Change of housing geometry S2L-SMT

Change of the housing geometry of all S2L-SMT flange versions.

S2L-SMT old geometry

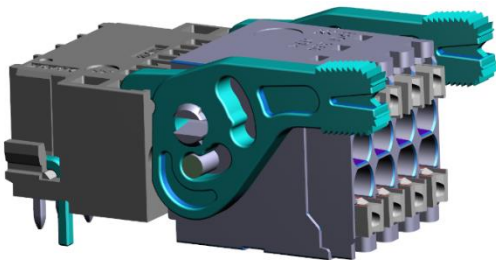
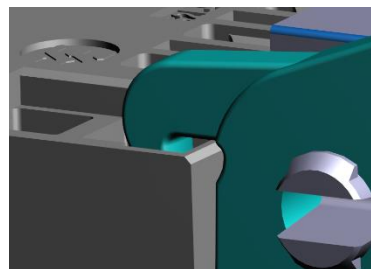
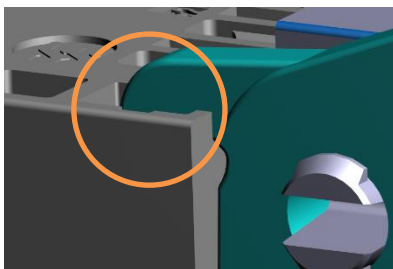
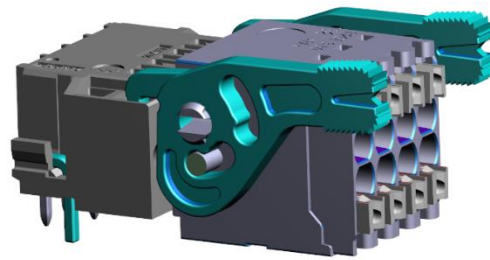
Due to that change, it is now possible to use B2L and B2CF with lock and release levers as counterpart. This was not possible with the old geometry, because of a collision of the levers with the S2L-SMT housing.
This change has no negative influence on electrical data acc. to the data sheet.
